GOVERNMENT OF INDIA
MINISTRY OF ENVIRONMENT & FORESTS
Central Zoo Authority

F. No. 19-62/92-CZA(27)(Vol. V)(M) 12054

DATE: 20.12.2011

Sub:- Construction of enclosures at Assam State Zoo, Guwahati and approval of Master (layout) Plan of the Zoo.

CONSERVATION CENTER OF GOLDEN LANGURE		
PREPARED BY		
G.K. DEV MEDHI		
ASSH. ENG. ASSAM STATE ZOO DIVISION		
SCALE		
1:300	DRN BY	
1:100,20	JUNU PRABHA KALITA

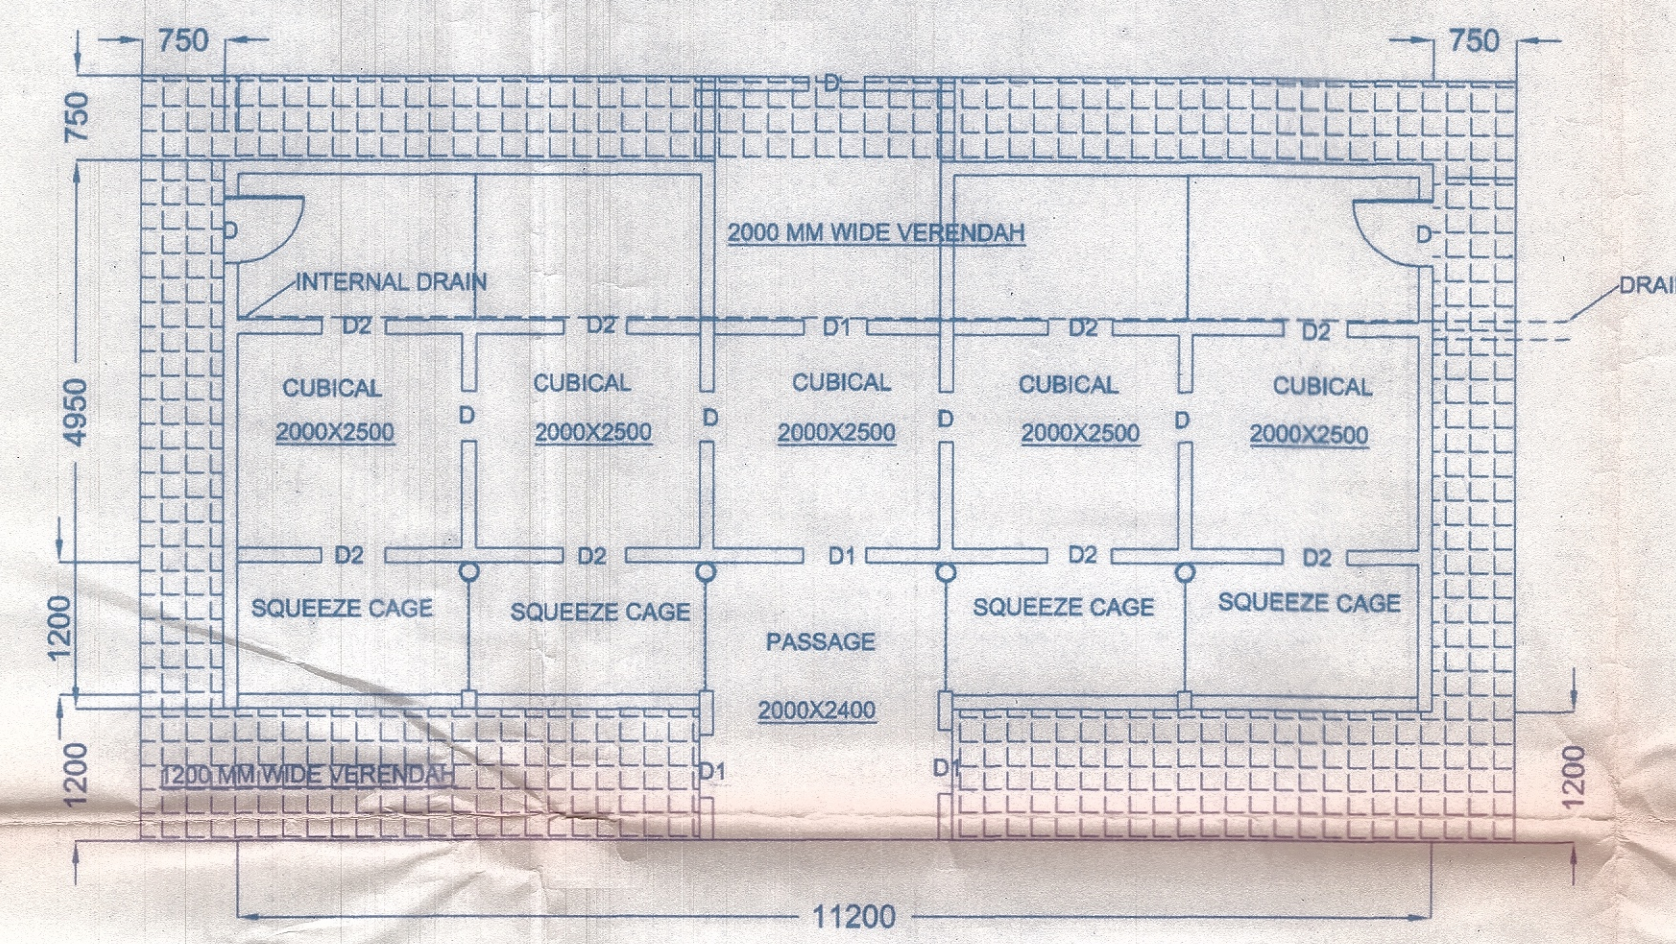
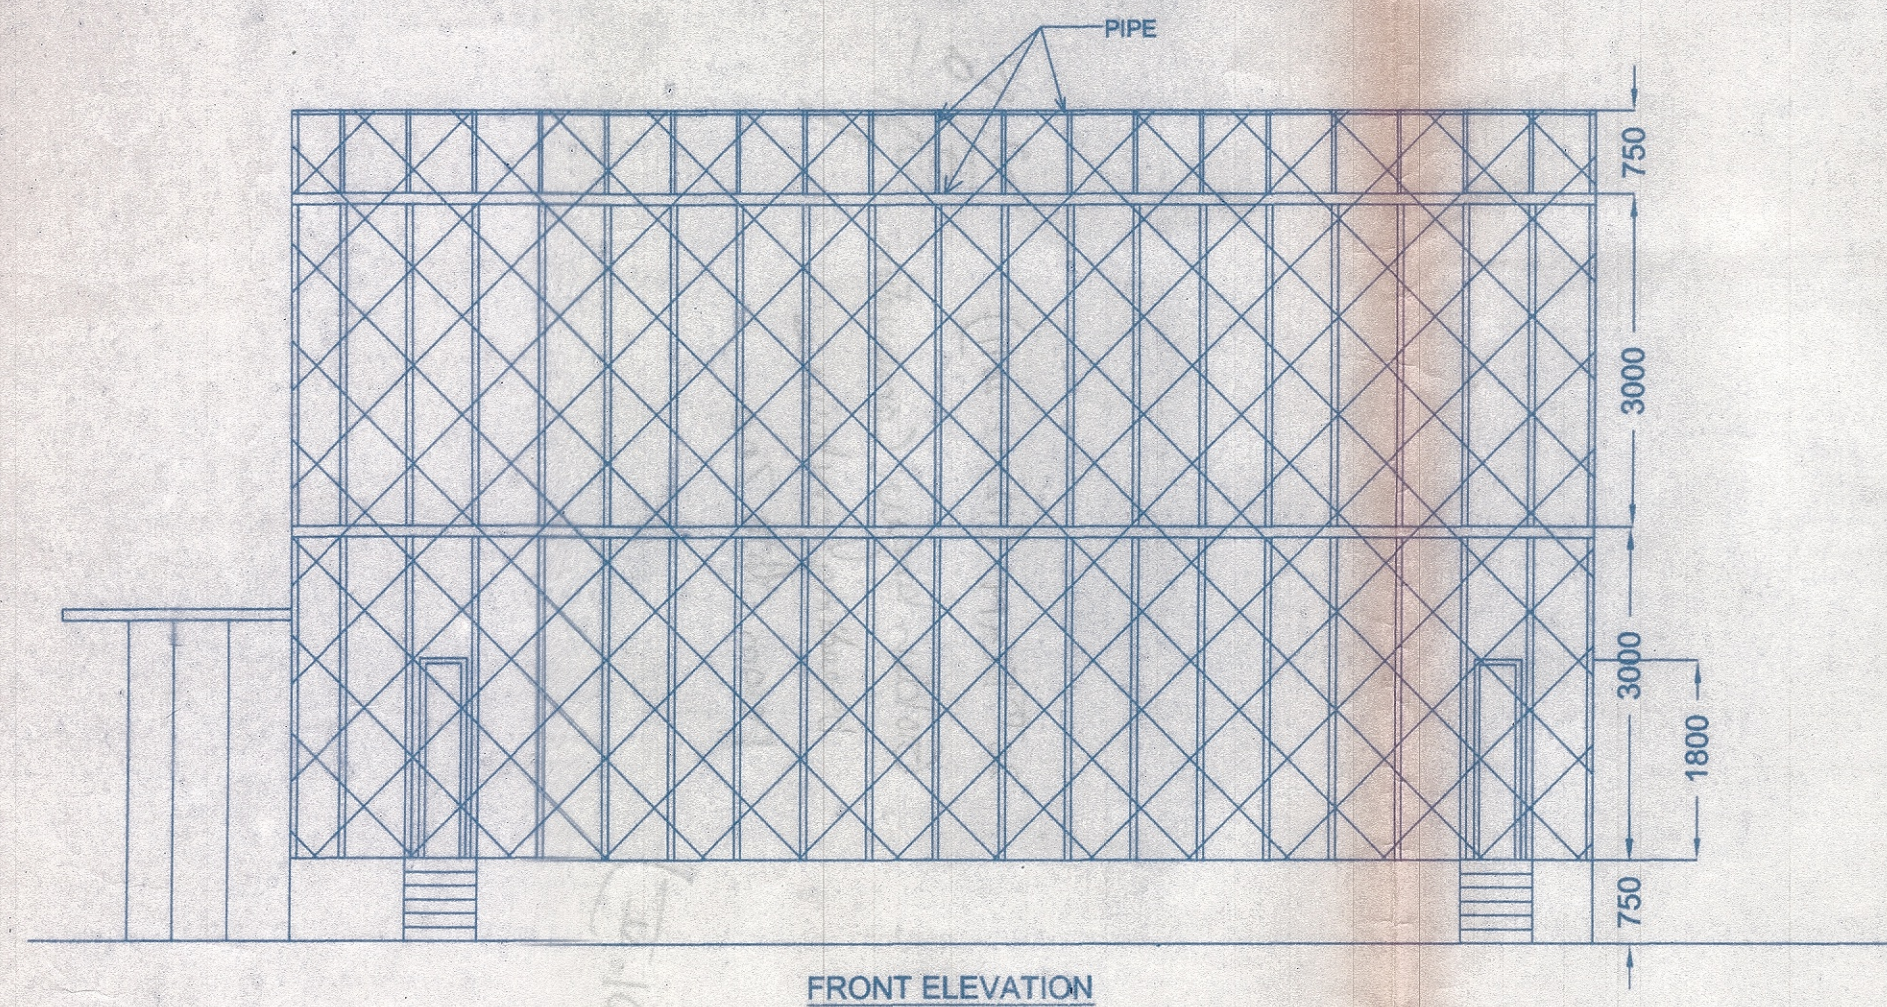
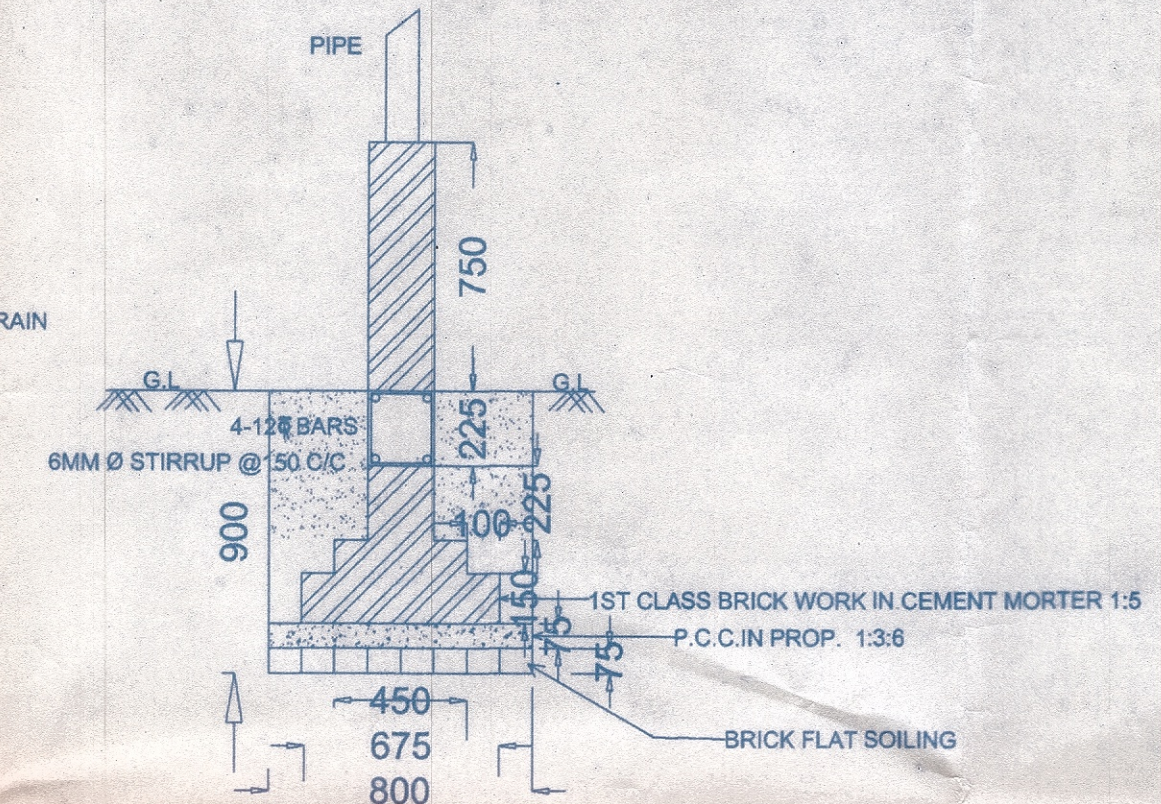
The design was approved subject to the following amendments (as indicated in plan by red ink):-

- The height of the inclined (inward) barrier should be kept of 1.5 meter.

- (b) The height of the chain-link mesh should be kept only 5 meter.
- (c) There should be screening between enclosures.
- (d) Every house should have 5 numbers of feeding and retiring cubicles.
- (e) The keeper gallery should have provision of sky light on top.
- (f) The keeper gallery provided in the animal houses of chamber I and II may be joined together.
- (g) The squeeze cage as proposed is not required instead portable squeeze cage may be used as and when needed.

Keeping in view of the above, revised design should be submitted to the Central Zoo Authority for records. A copy of the design indicating the necessary changes to be carried out is enclosed for your perusal.
